Subject
UNDERHOOD 30/40 Water Pump Compatibility in Ford 6.7L Diesel 2017+

Figure 1 – Identifying compatible secondary cooling system water pump.

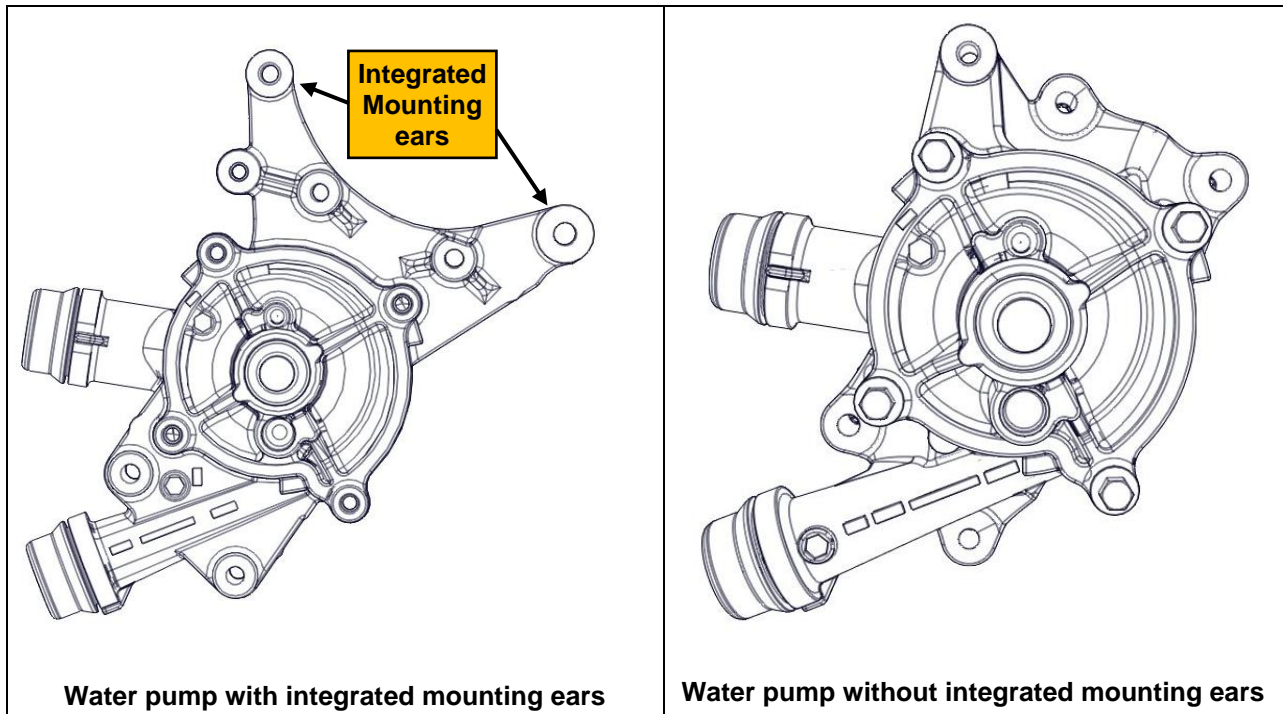
The UNDERHOOD compressor systems listed above are designed to fit vehicles that are equipped with secondary cooling system water pumps that have integrated mounting ears.

If the vehicle is not equipped with a secondary cooling system water pump with integrated mounting ears, the following adaptor kits must be ordered prior to fitting main bracket (Figure 1):

- V300011 and V400011 - VMAC adaptor kit P/N: [A900018](#)
- V400021 and V400030 - VMAC adaptor kit P/N: [A900022](#)
